Re: **College Center Expansion – Building 600**

RFP No 20-21-17

Addendum #4

RFI Questions and Response

G0.02

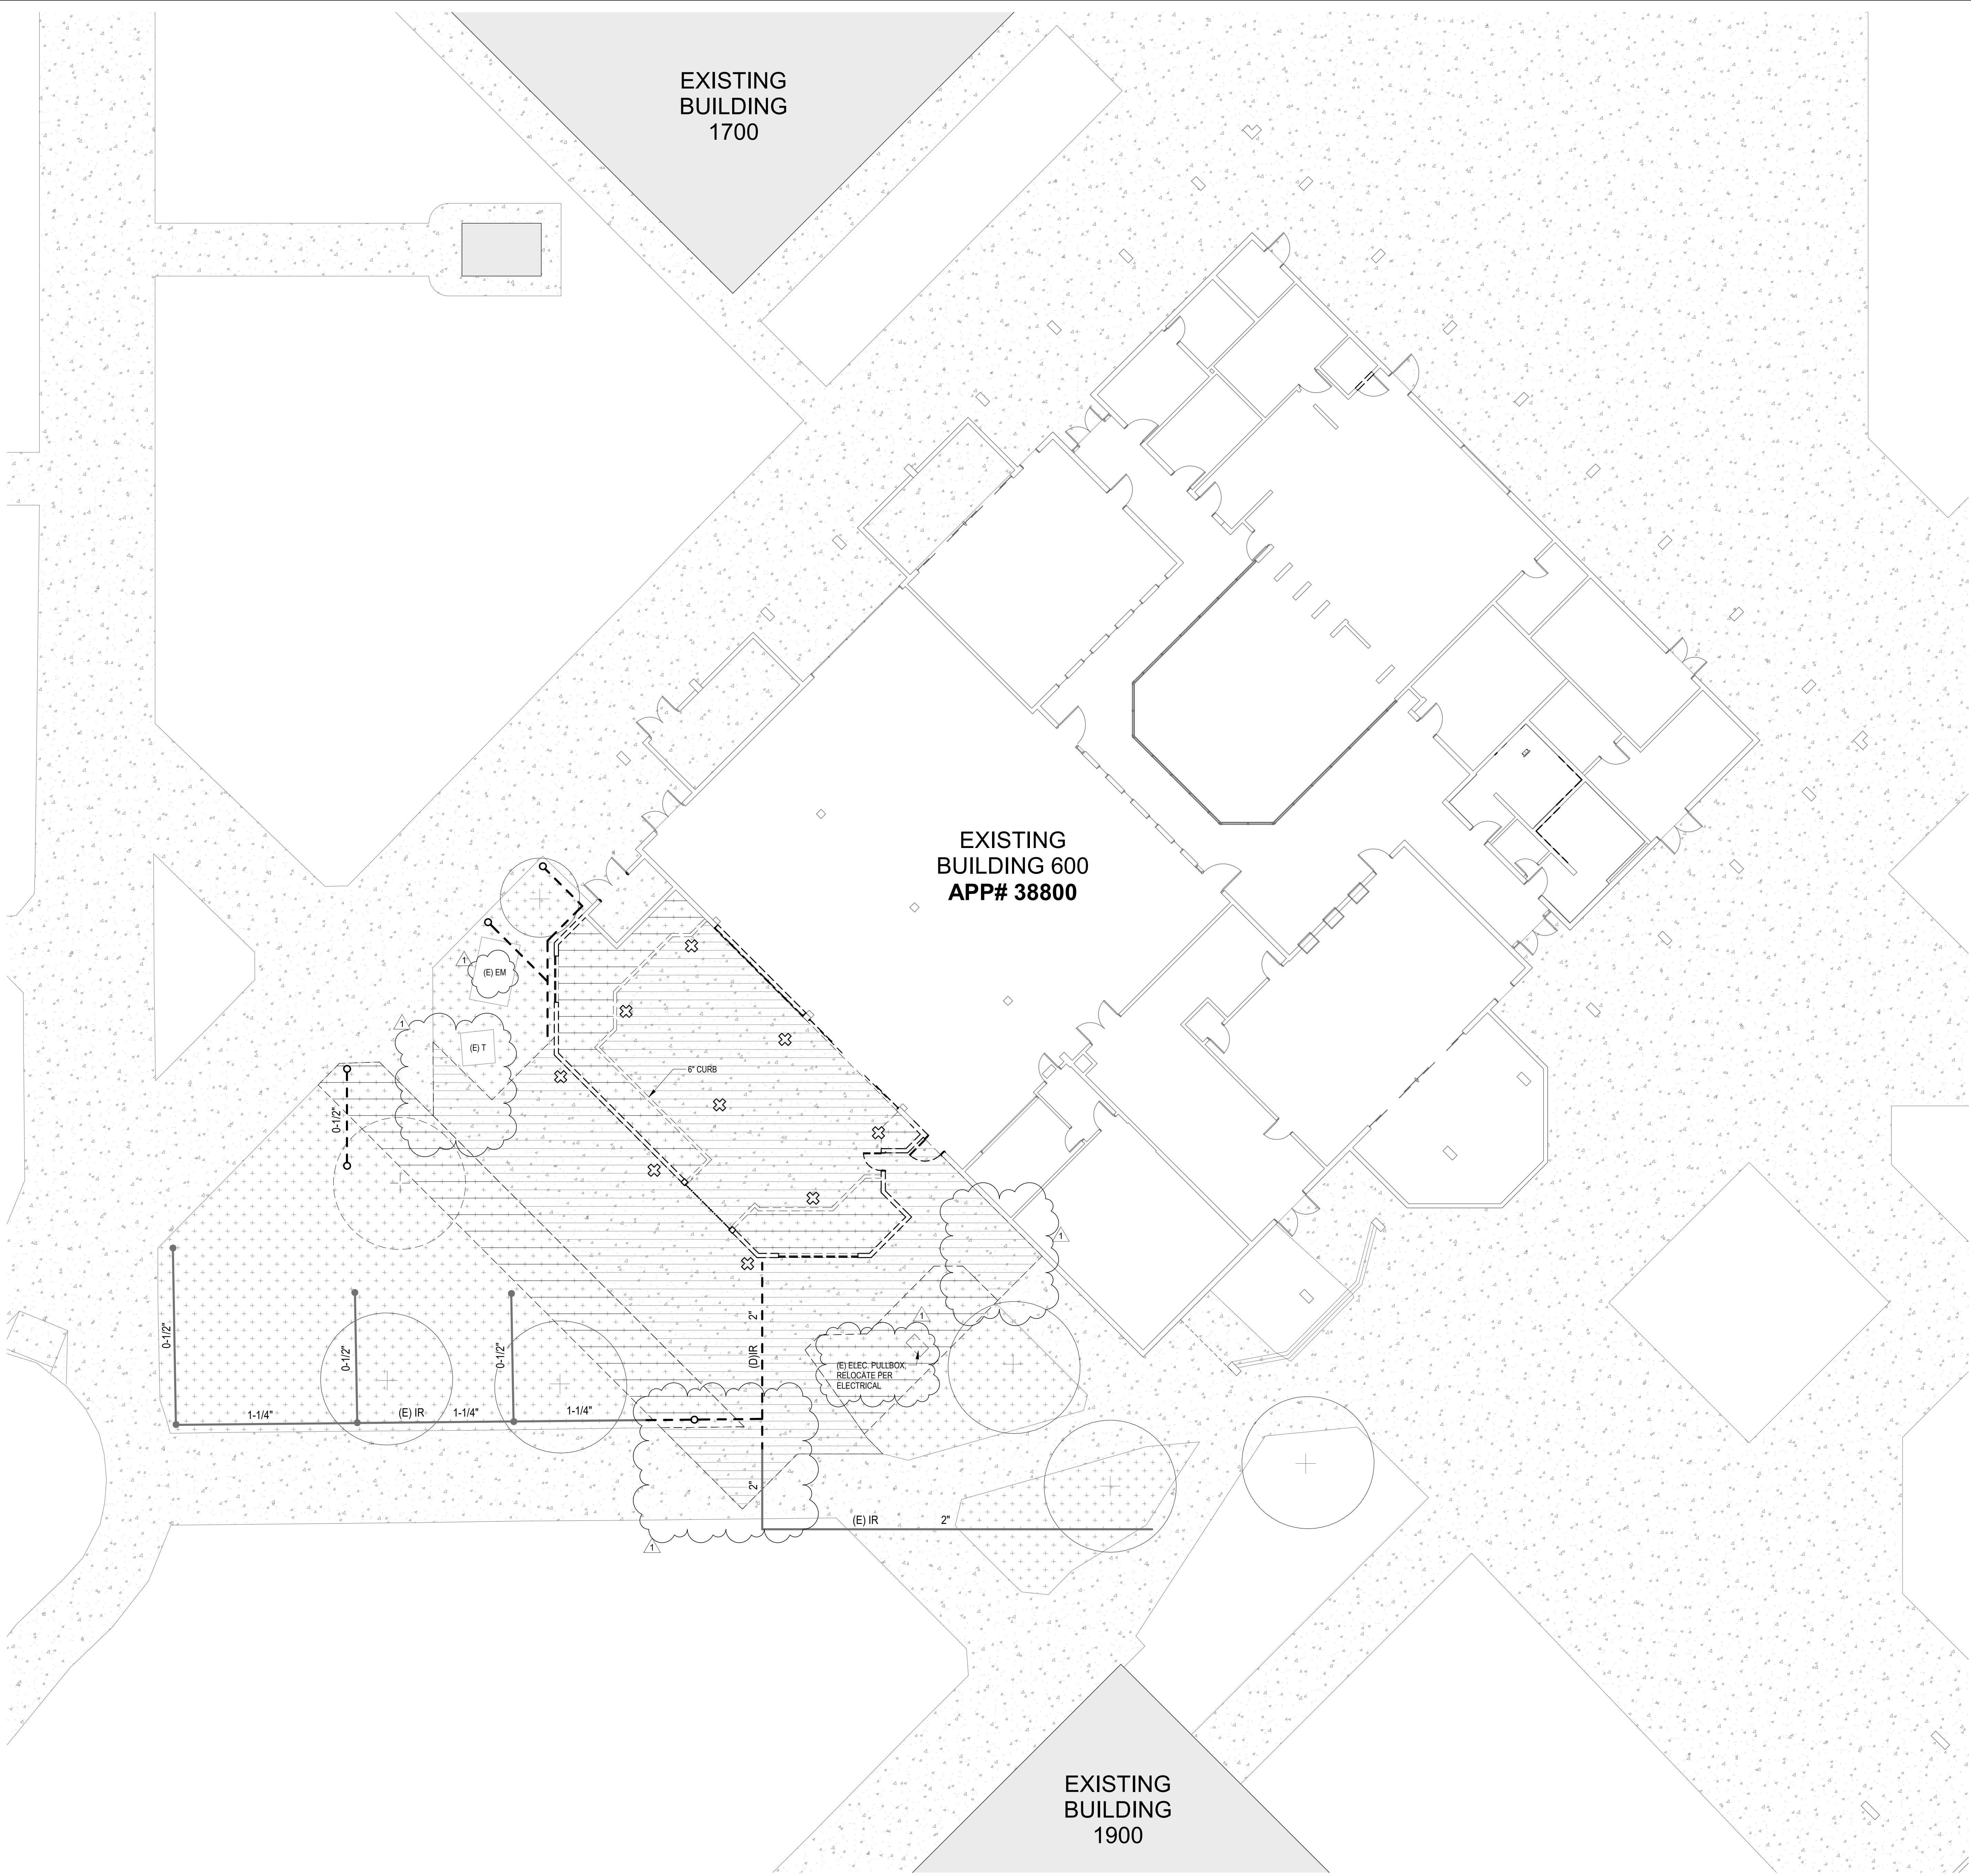
9. **Question:** On Sheet G0.02 callout 21/A1.02 was eliminated, is there any work in this area?

Detail 21 on Sheet A1.02 was changed removing (N) for the new concrete ramp symbol. As drawn, are we to replace truncated dome panel, install a sign and stripe the area. Please be specific.

Response: The call out 21/A1.02 on sheet G0.02 was added back into the drawings and the detail was modified on the attached revised Addendum 1 (ADD_01_V2).

A10.01

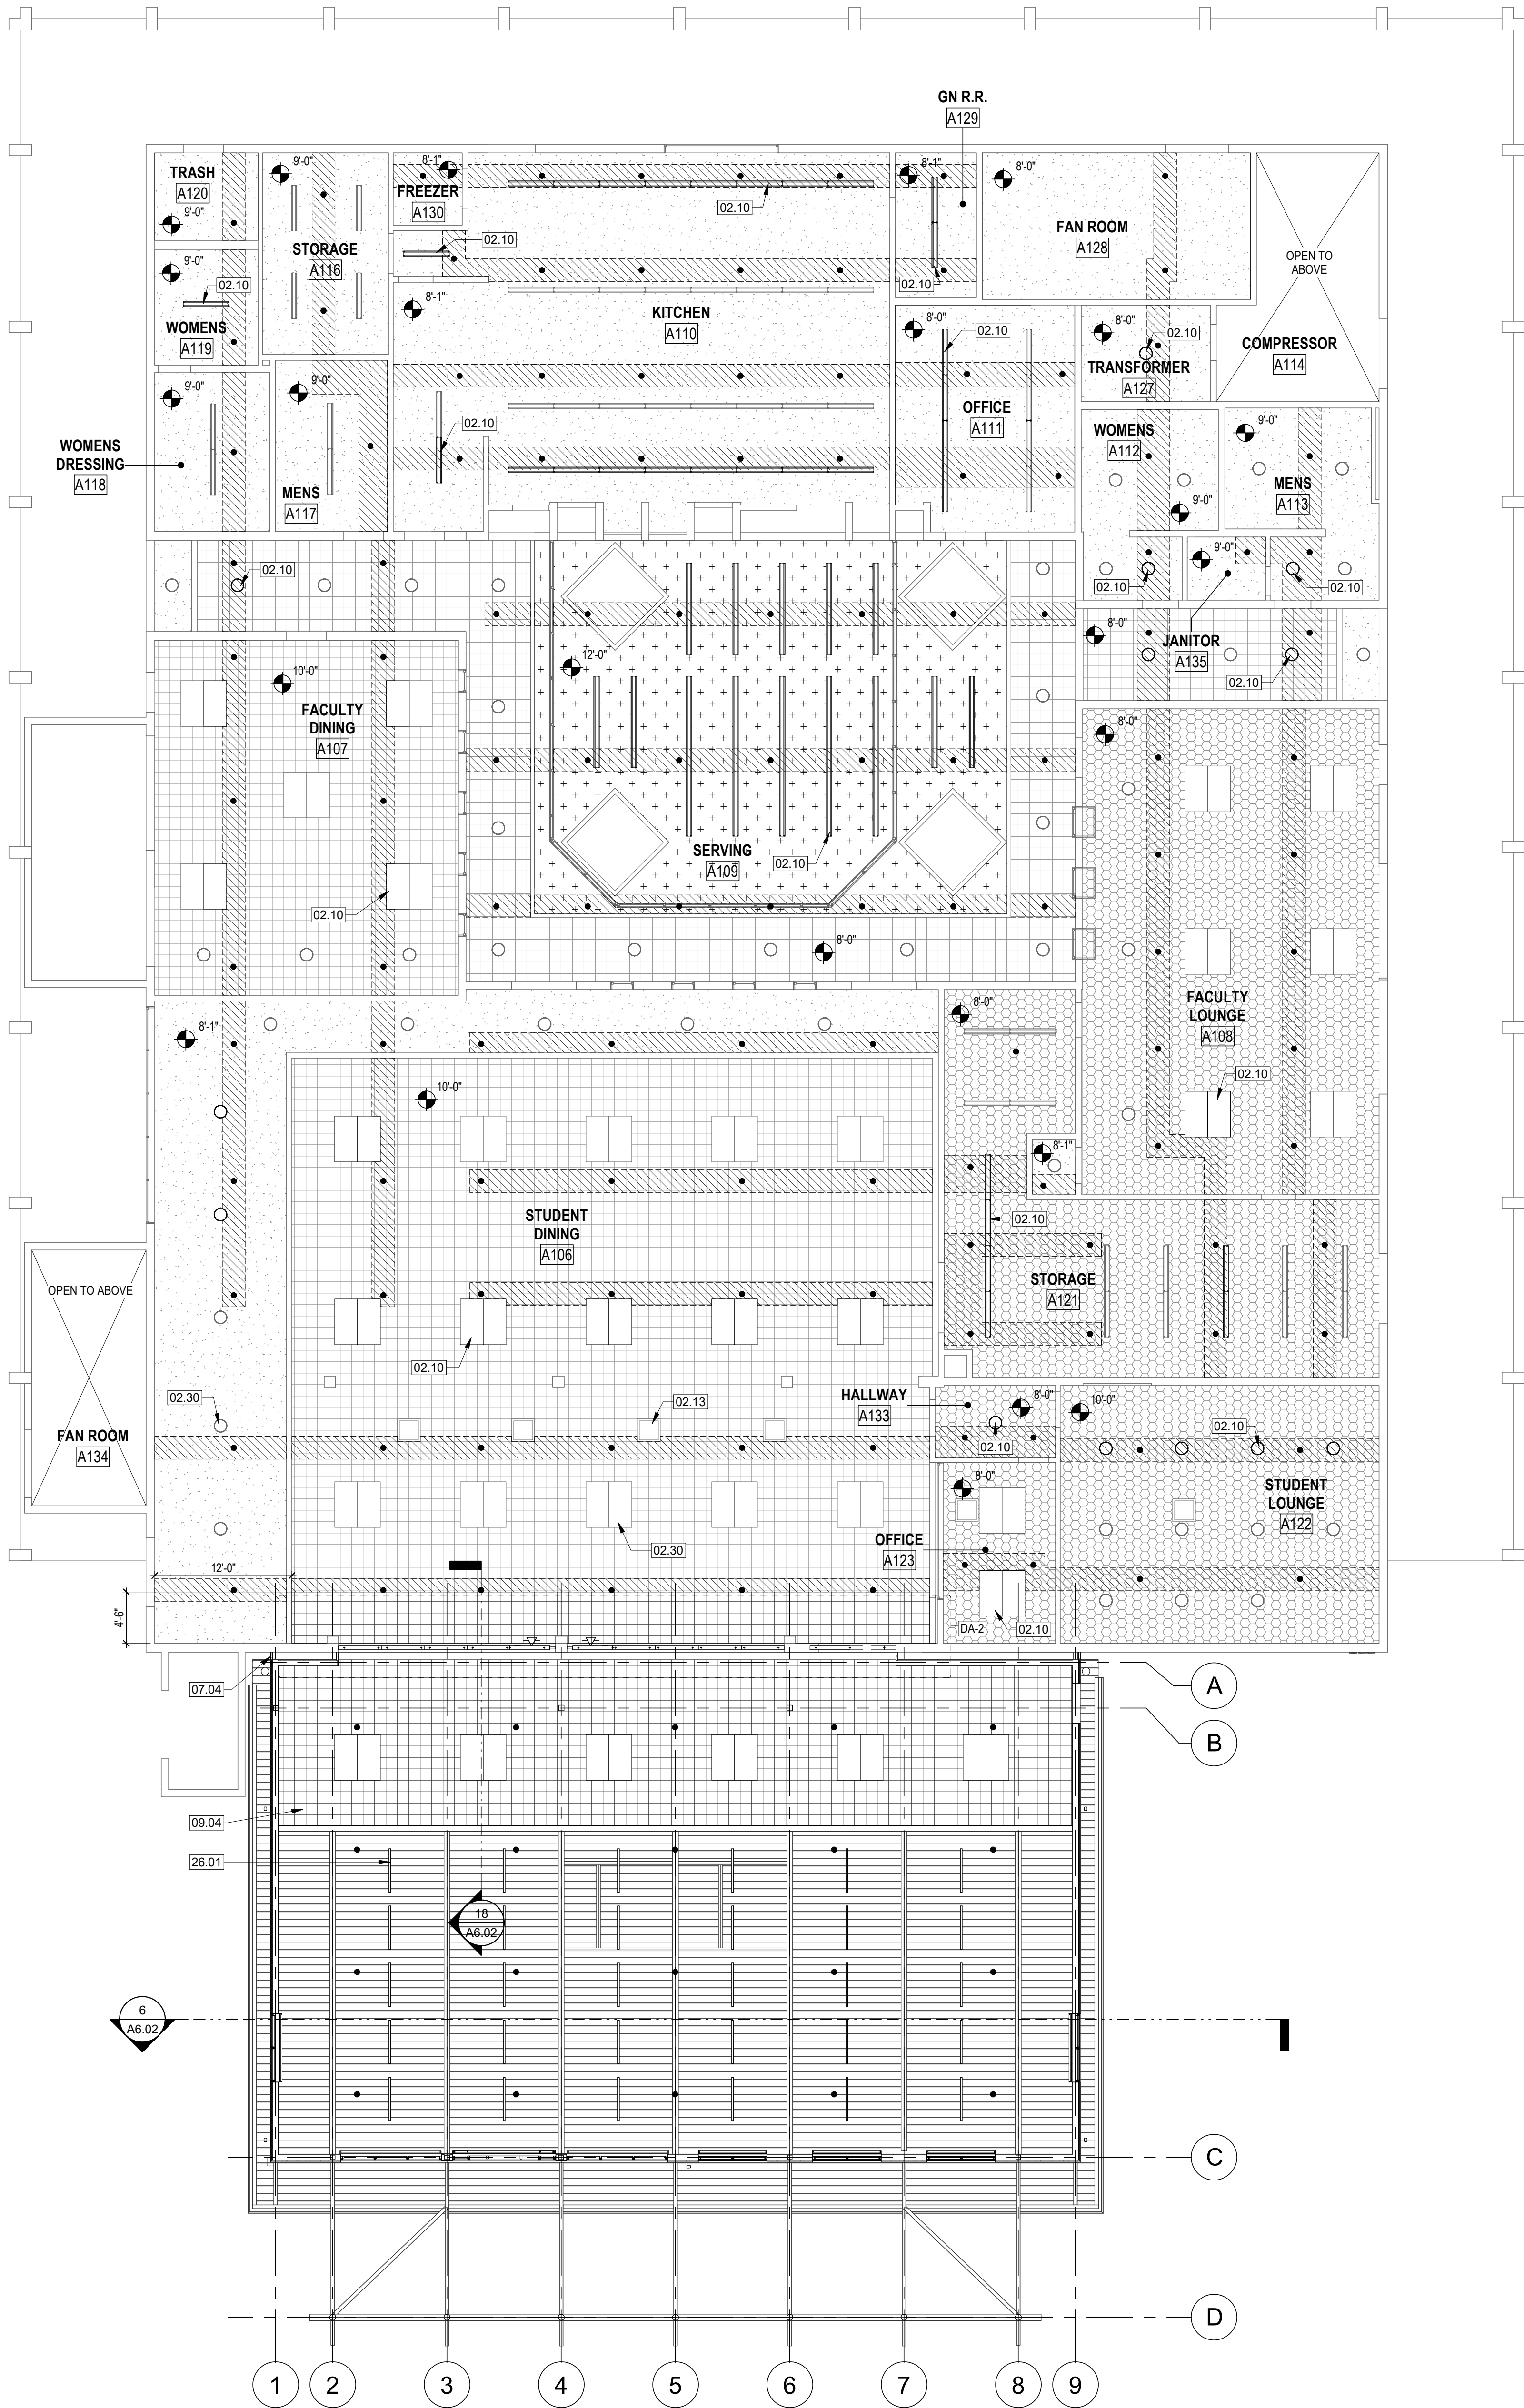
11. **Question:** Page A6.04 has callouts for the Drop Ceiling Details on A10.03 which has not been provided.

Response: See sheet A10.03 on the attached revised Addendum 1 (ADD_01_V2).
